STAFF REPORT FOR THE HISTORIC REVIEW BOARD

FILE NUMBER: DR-11-07

REQUEST: Commercial Minor Remodel

1817 and 1823 Willamette Falls Dr. - Exterior Alteration Narrative
Response to Staff's Summary of May 5, 2011 Pre-Application Meeting
Prepared for Sara Javoronok, West Linn Associate Planner and the West Linn HRB
Applicant: Darren Gusdorf, Icon Construction and Development
Date submitted: May 6th, 2011

SHEET NO. **A1**

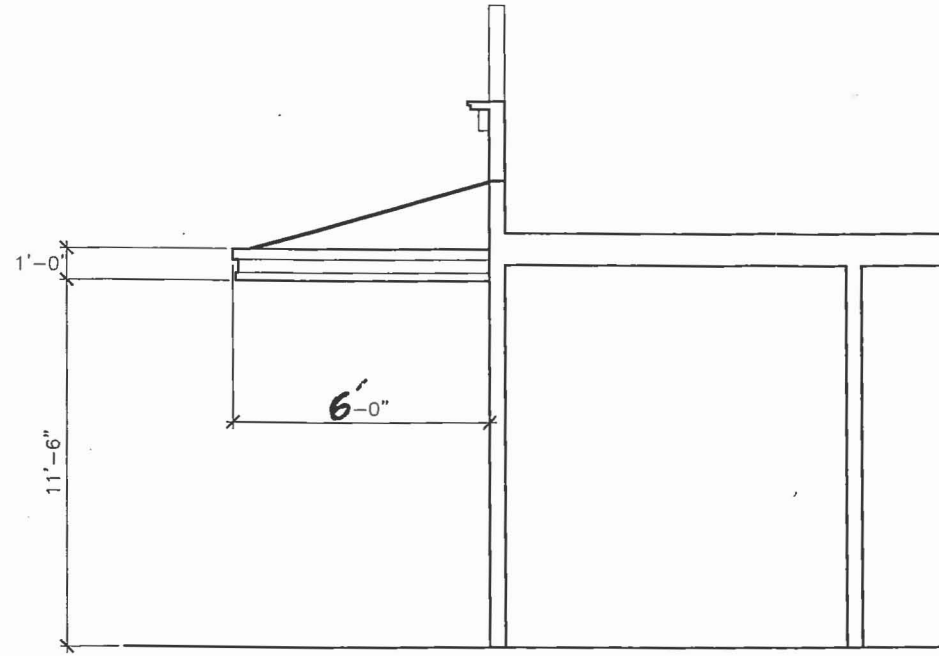
FINDING NO. 4: For 1823 Willamette Falls Drive, the applicant is proposing a steel awning above the transom windows that will extend across the entire façade of the building. The criteria specify that the awning shall be canvas, vinyl, or similar approved material. There are other steel awnings that have been approved in the Willamette Falls Drive Commercial District. Examples include 1705, 1877, and 1914 Willamette Falls Drive. The applicant is proposing two different options for the underside of the awning. Option A is tongue and groove 1x6 cedar with recessed can lighting similar to 1889 Willamette Falls Drive. Option B is a box beam with cedar soffits and surface mount lighting (Photo #4 in the applicant's submittal). Both proposed awning Option A and Option B meet the criteria.

For 1823 Willamette Falls Drive, the applicant is proposing to alter the existing single door entry to an entry with two doors. The doors will be wood and will match the existing doors at 1889 Willamette Falls Drive. The applicant will not alter the existing setback of the doors which is 2'6". The doors will have glazing in the upper 2/3 of the door. There is a single panel on the lower 1/3 of the door. There will be windows on the side of the entry doors. The criteria are met.

FINDING NO. 8: No additional lighting is proposed for 1817 Willamette Falls Drive. For 1823 Willamette Falls Drive, uplighting is proposed for sign lighting. As mentioned above, can lighting (Option A) or surface mount lighting (Option B) are proposed for the underside of the awning. The

can lighting is modern, simple, and does not attract attention. The surface mount lighting is more aligned with the historic period of the Commercial District. The criteria are met.

1. Elevations. With the exception of modifications required by these conditions, the project shall conform to the elevation A1 dated April 21, 2011 in Exhibit HRB-3.
2. Entryway. The restored entrance at 1817 Willamette Falls Drive shall match the door depicted in Photo #2 in Exhibit HRB-3.
3. Lighting. The lighting shall not create off-site glare.
